APP-153

Code of Practice for Fire Safety in Buildings 2011

Amendments to the Code of Practice for Fire Safety in Buildings 2011 (April 2012)

Corrigenda to the Code of Practice for Fire Safety in Buildings 2011 (FS Code) (April 2012)

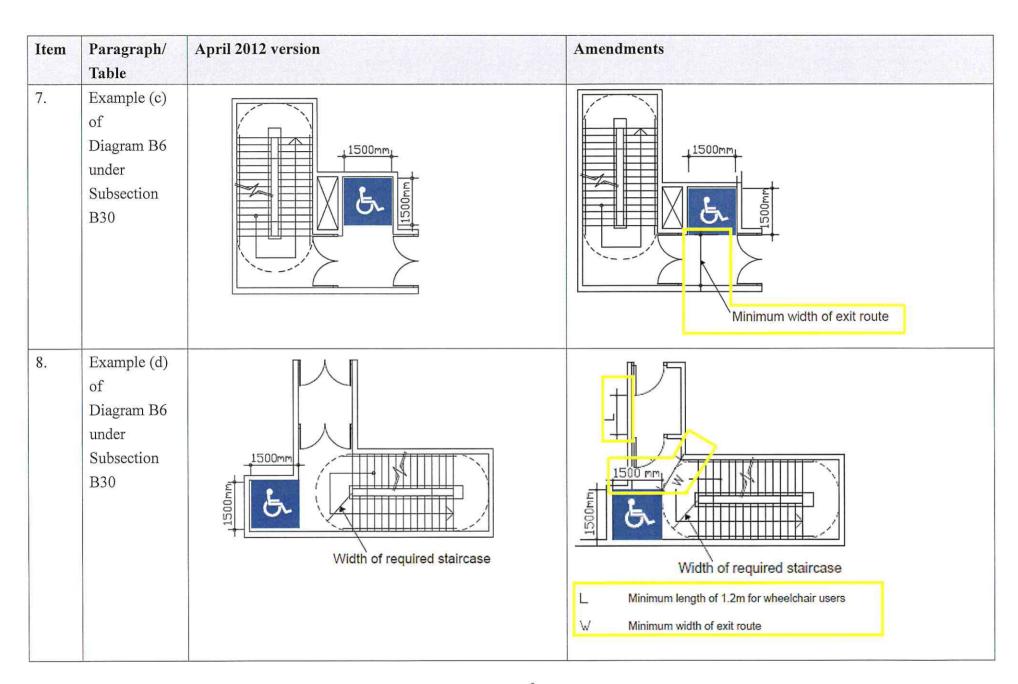
Item	Paragraph/	April 2012 version	Amendments
	Table		
6.	Example (b) of Diagram B6 under Subsection B30	D EXIT EXIT	D 1500nm 1500nm D 2500nm D 25
		Lobby to fireman's lift of minimum dimensions of 1.5m to be used as wheelchair manoeuvring space	Lobby to fireman's lift of minimum dimensions of 1.5m to be used as wheelchair manoeuvring space
		1.5m x 1.5m wheelchair manoeuvring space at 3.5m deadend	1.5m x 1.5m wheelchair manoeuvring space at 3.5m deadend
		Temporary refuge space (0.75m x 1.5m) in fireman's lift lobby	Temporary refuge space (0.75m x 1.5m) in fireman's lift lobby W Minimum width of exit route
		D Fire rated door for accommodation	Minimum width of exit route D Fire rated door for accommodation
			Accessible Lift

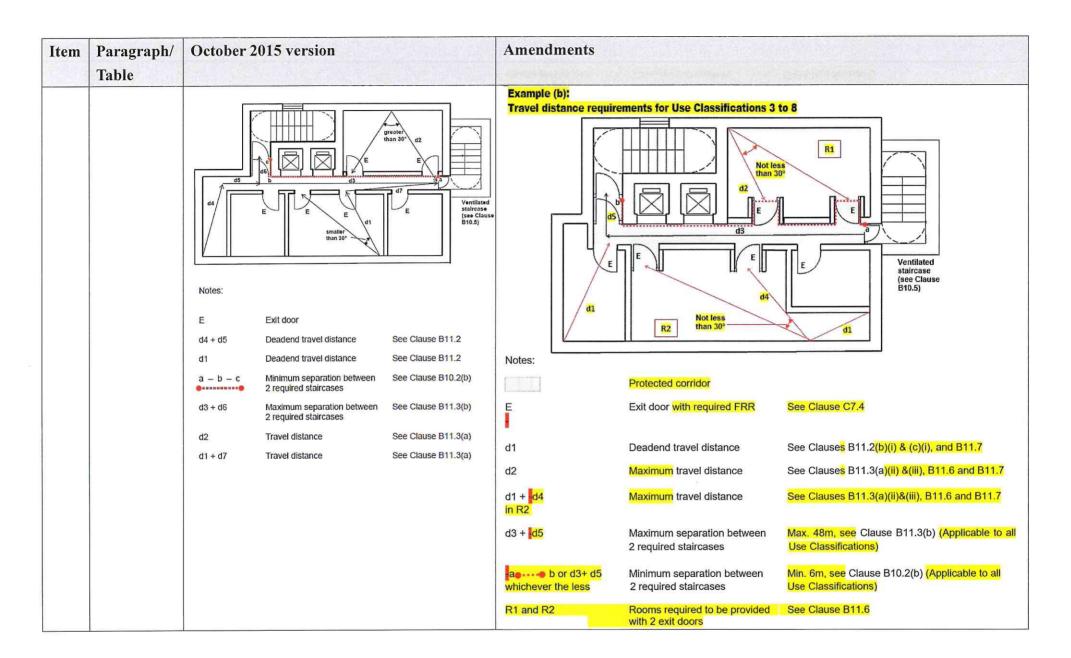
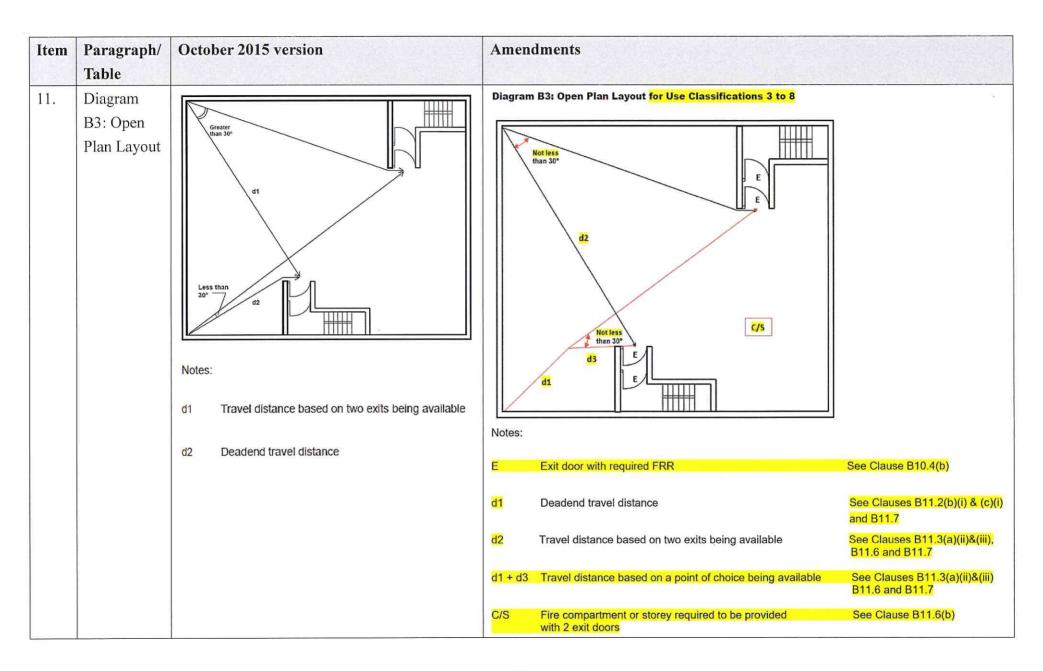
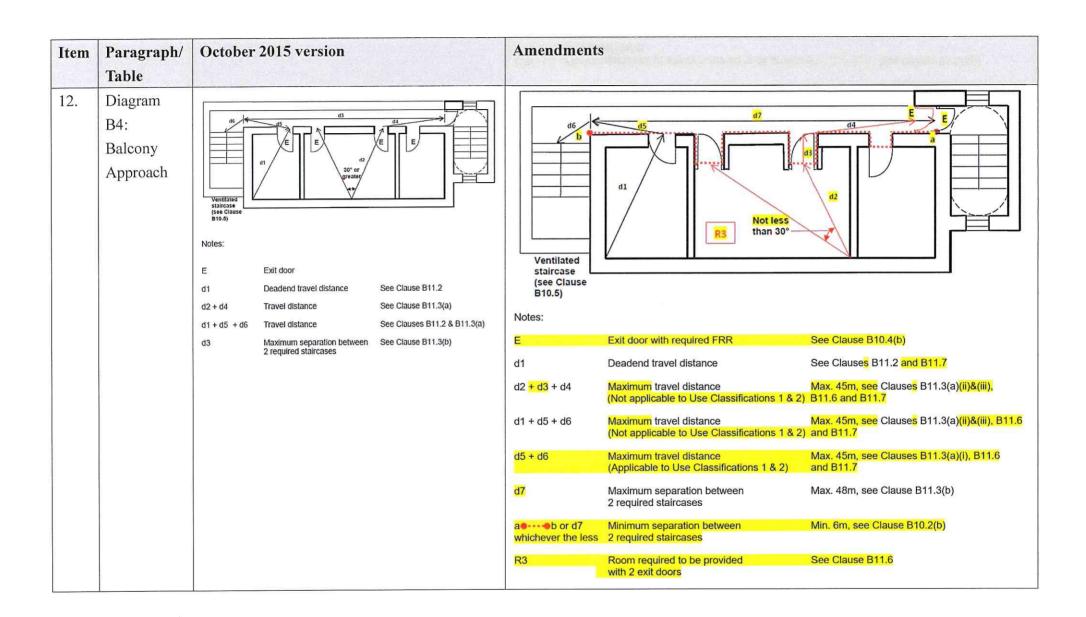
Item	Paragraph/ Table	October 2015 version	Amendments
10.	Diagram B2: Internal Corridor Access		Example (a): Travel distance requirements for Use Classifications 1 and 2
			Notes: Protected corridor
			E Exit door with required FRR See Clause C7.4 d1+d2 Deadend travel distance d1: Max. 24m, see Clauses B11.2(a)(i) and B11.7 d2: Max. 15m, see Clauses B11.2(a)(ii) and B11.7
			d3 Maximum travel distance Max. 24m, see Clause B11.3(a)(i)
			d4 + d5 Maximum separation between Max. 48m, see Clause B11.3(b) (Applicable to all Use Classifications)
			all whichever the less Minimum separation between whichever the less Minimum separation between Use Classifications)
